CAMBRIA COMMUNITY SERVICES DISTRICT

Subject: Information Hold Letter No 2 DRC2013-00112 (Cambria Community Services District)
Development Plan/Coastal Development Permit

20. CZLUO 23.07.080 (Geologic Study Area (GSA))

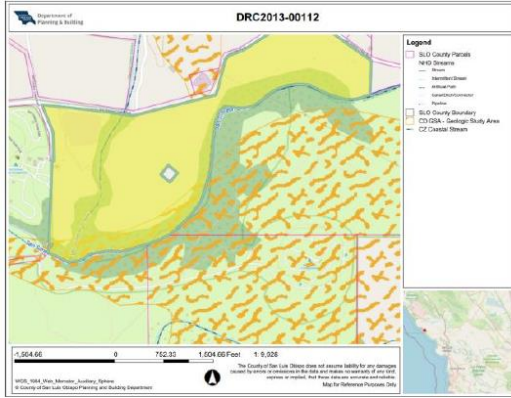
- a. Project is located within the Geologic Study Area (GSA), see below. A Geologic Study Area combining designation is applied by the Official Maps (Part III) of the Land Use Element, to areas where geologic and soil conditions could present new developments and their users with potential hazards to life and property. These standards are applied where the following conditions exist Moderate potential for liquefaction and landslide risk. Please provide an engineering soils report.

District Response: Please see Exhibit 2 and 2.1.

21. CZLUO 23.07.060 - Flood Hazard Area (FH)

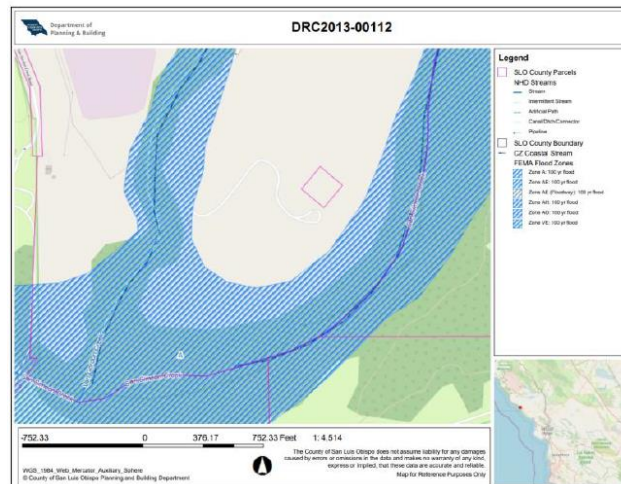
- a. Project is located in the Flood Hazard area, see below. A drainage plan approval is required where any portion of the proposed site is located within a Flood Hazard combining designation. Please provide a drainage plan, see Public Works Comment letter.

District Response: Please see Exhibit 2.
